**FINDINGS AND RECOMMENDATION
OFFICE OF PLANNING AND ZONING
ANNE ARUNDEL COUNTY, MARYLAND**

CASE NUMBER: 2025-0040-V

The applicants are requesting a variance to allow a new dwelling and an accessory structure (pool) with less setbacks and buffer than required, disturbance to slopes of 15% or greater, and the new dwelling that does not comply with the designated location of a principal structure on a waterfront lot on property located at 1836 Cove Point Road in Annapolis.

VARIANCE PLAN
1836 COVE POINT ROAD
1836 COVE POINT ROAD, ANNAPOLIS, MD 21401
TAX ACCT. NO. 02-000-02456700
TAX MAP 045F GRID 0002 PARCEL 0540 DISTRICT 2ND
ANNE ARUNDEL COUNTY, MARYLAND

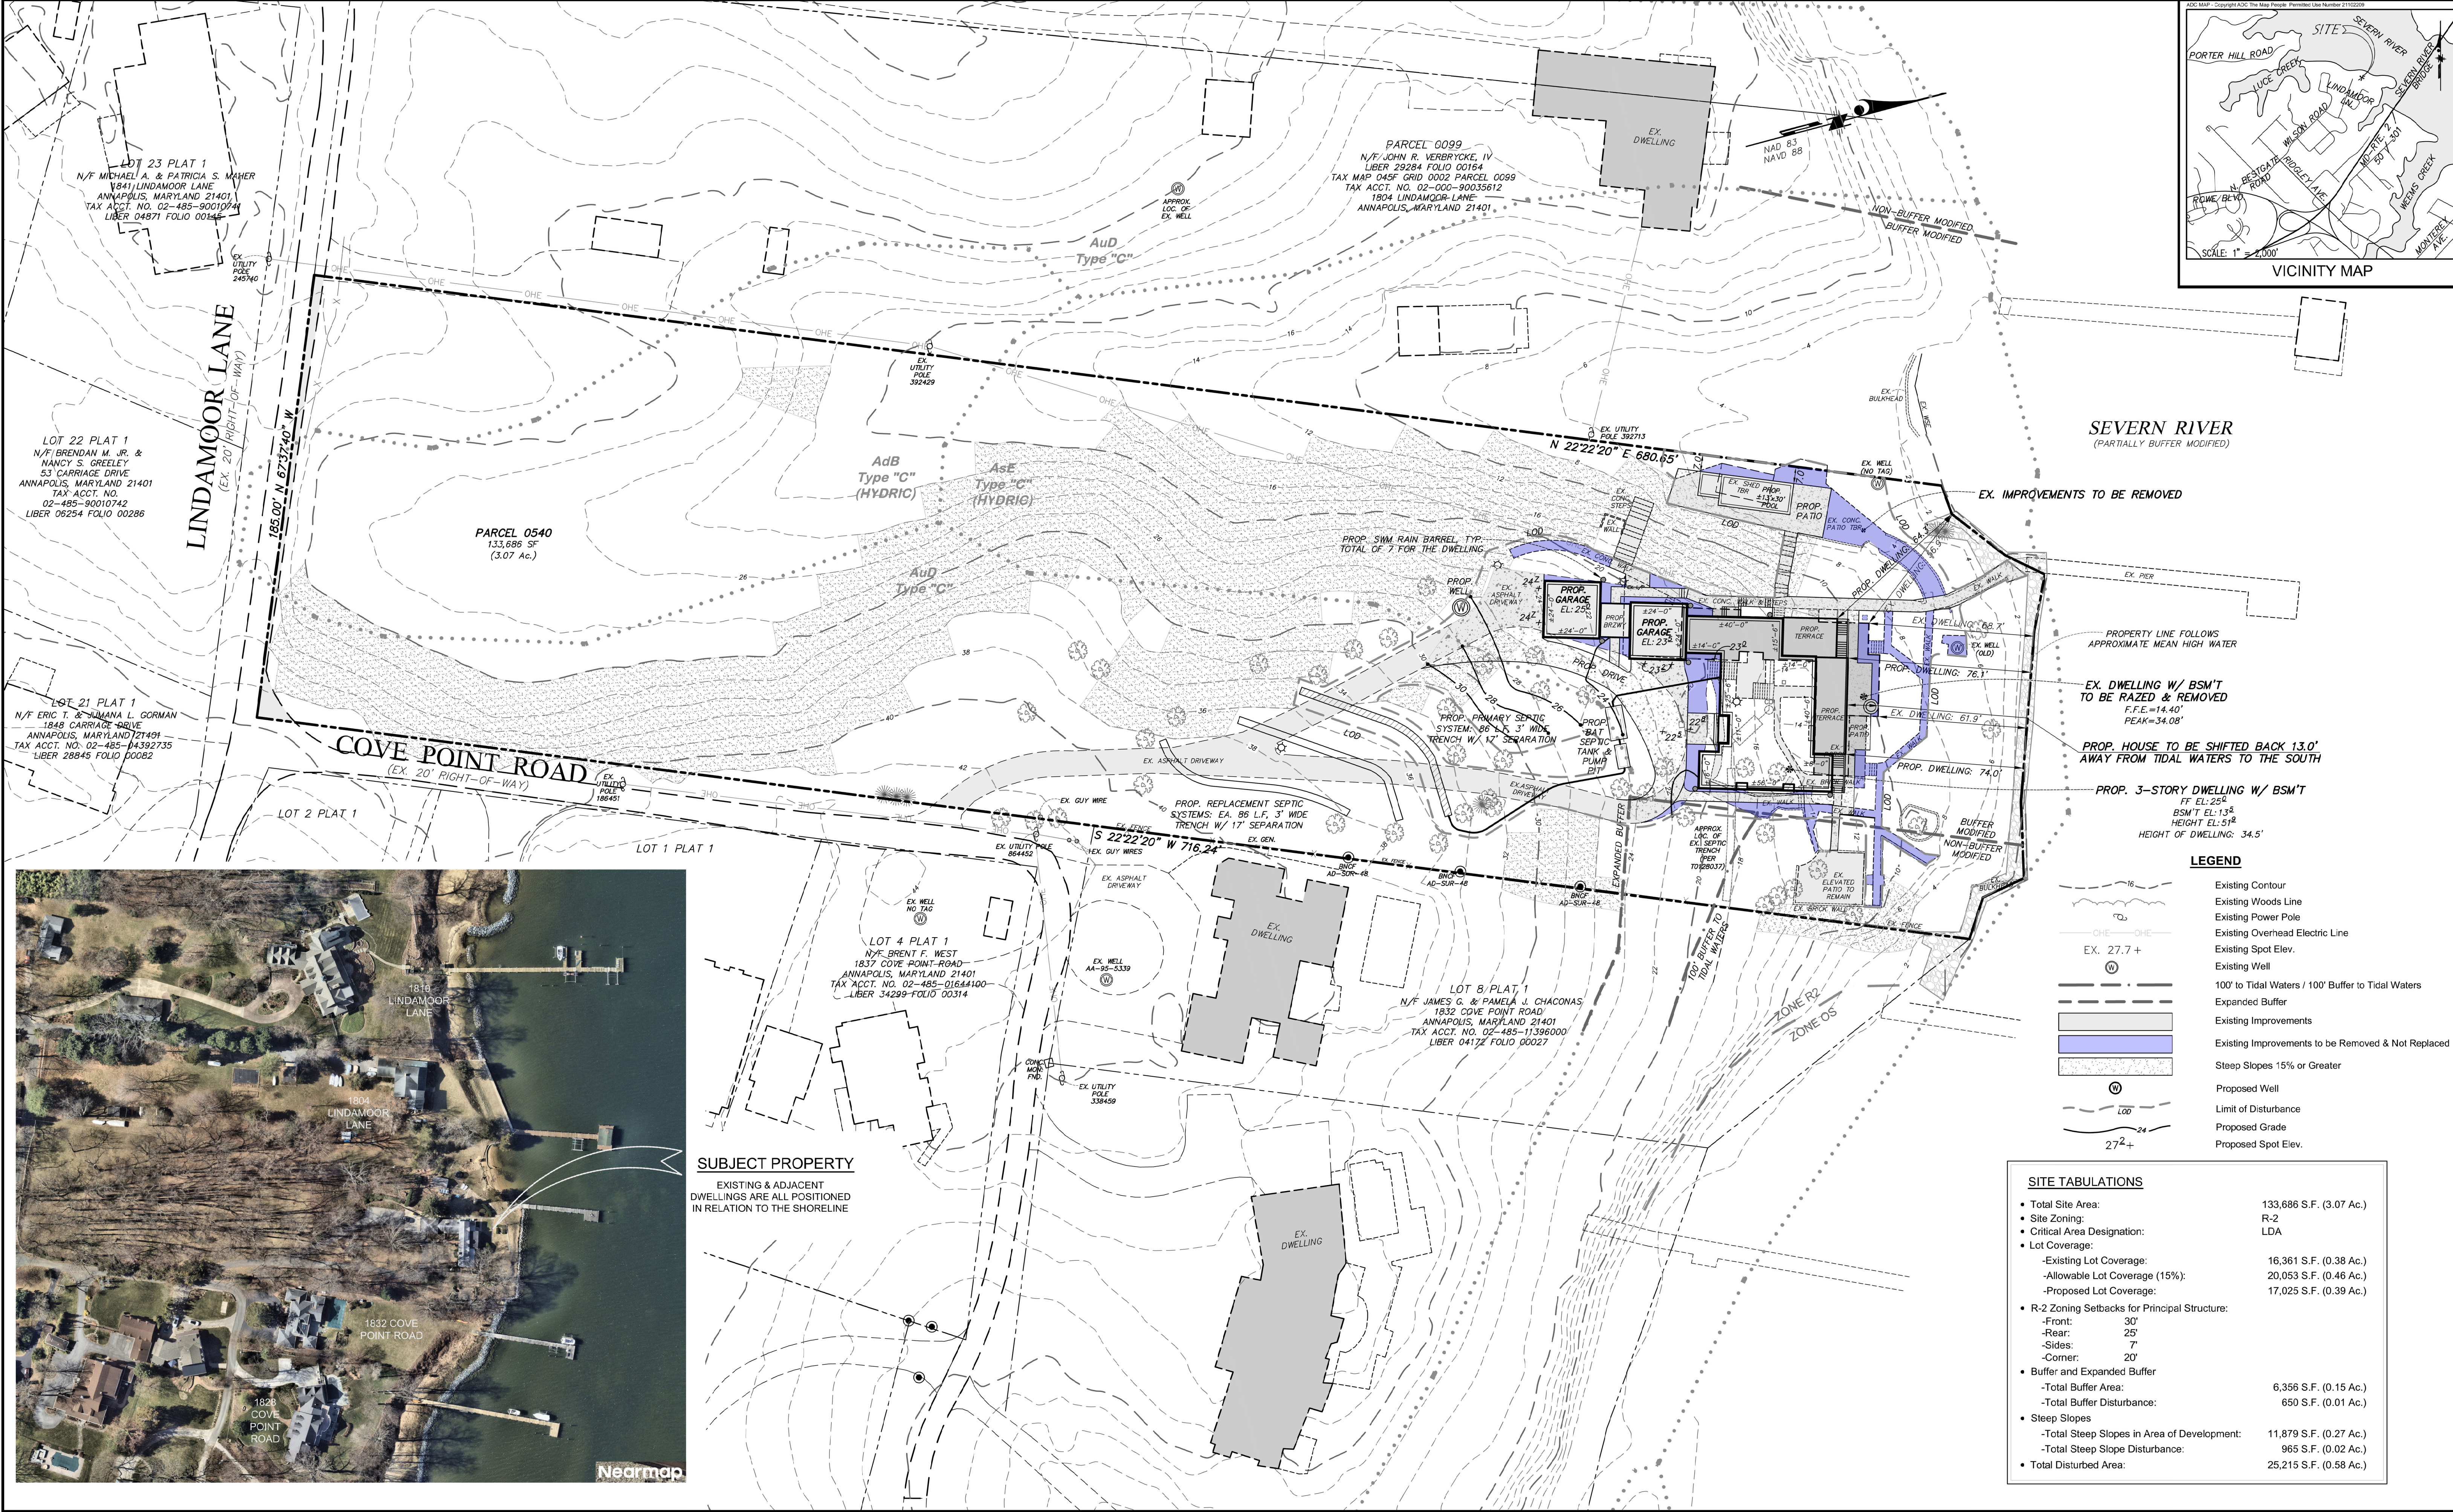
This Office has no objection to the location of the pool/patio provided the applicant can demonstrate that there will be no additional slope disturbance related to the location. The site plan is not clear since the symbols used for steep slopes and paving are very similar.

- 1. According to the Letter of Explanation, the site is zoned R-1. However, according to the Chesapeake Bay Critical Area Report, the header line above the Site Description section states the zoning is R-2, and in the Site Description section (the first paragraph) of the report, it states the site is zoned as R-1. The Variance Plan states the zoning as R-2. Ensure the zoning is consistent across all of the submitted documents.

- 2. It is acknowledged that a combined existing and proposed conditions Variance Plan was submitted. However, for clarity, please submit an existing conditions Variance Plan and a separate proposed conditions Variance Plan.

- 3. On the Site Plan, show the Limit of Disturbance (LOD). Additionally, although it is stated on the Critical Area Project Notification Sheet, on the Site Tabulations table on the Site Plan, state the Total Disturbed Area.

- 4. It does not appear the entirety of the steep slopes are shown on the Site Plan. On the Site Plan, show all of the steep slopes on and off the site.

- 5. On the Site Plan, show the rain barrel locations and their sizes and identify where the rainwater collected in these barrels will be discharged.
- 6. Label the bold lines going through the proposed primary septic system field. If these are proposed contours, label them accordingly and include this symbol in the legend.
